FAQ Number 16-0011 FAQ Revision 1

FAQ Title Cable Tray Ignition

Plant: <u>Harris</u>	Date: <u>June 2, 2016</u>
Contact: _____	Phone: <u>(919) 546-4570</u>
<u>Harold Stiles</u>	Email: Harold.Stiles@Duke-Energy.com
<u>Robert Cavedo</u>	Robert.Cavedo@ExelonCorp.com
<u>Francisco Joglar</u>	FJoglar@jensenhughes.com
<u>Kyle Christiansen</u>	Chris1K@Westinghouse.com
<u>Young Jo</u>	ygio@southernco.com

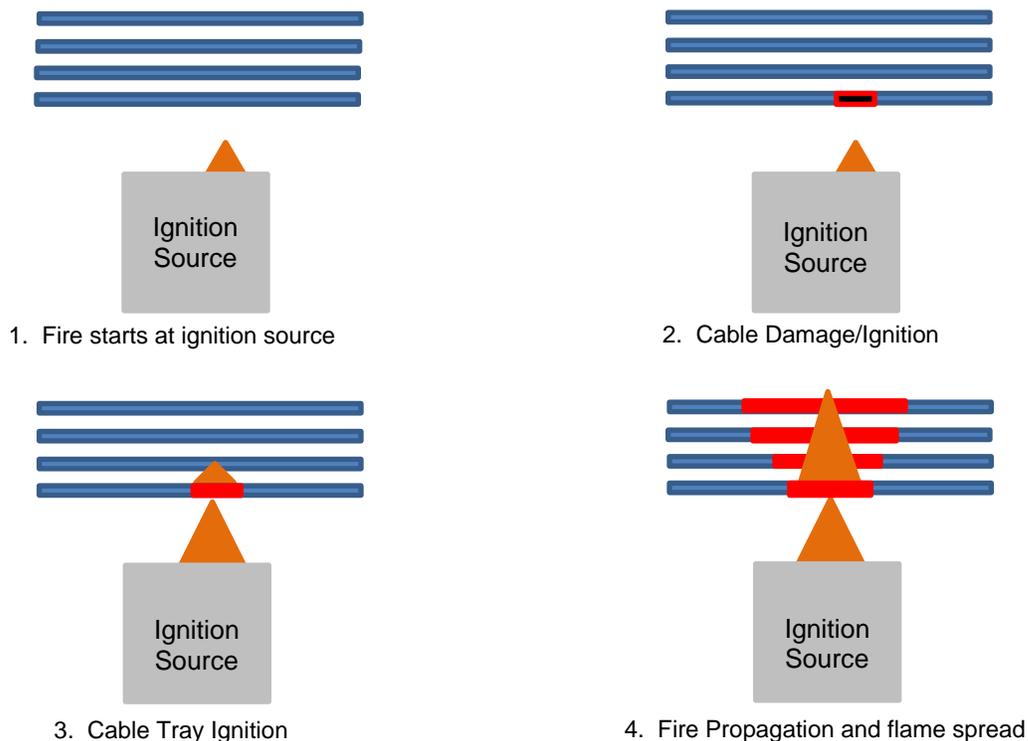
The above time line is recommended for growing fires only. The timeline is not applicable for high energy arcing fault fire scenarios. Figure 1 provides a pictorial representation of the recommended timeline.
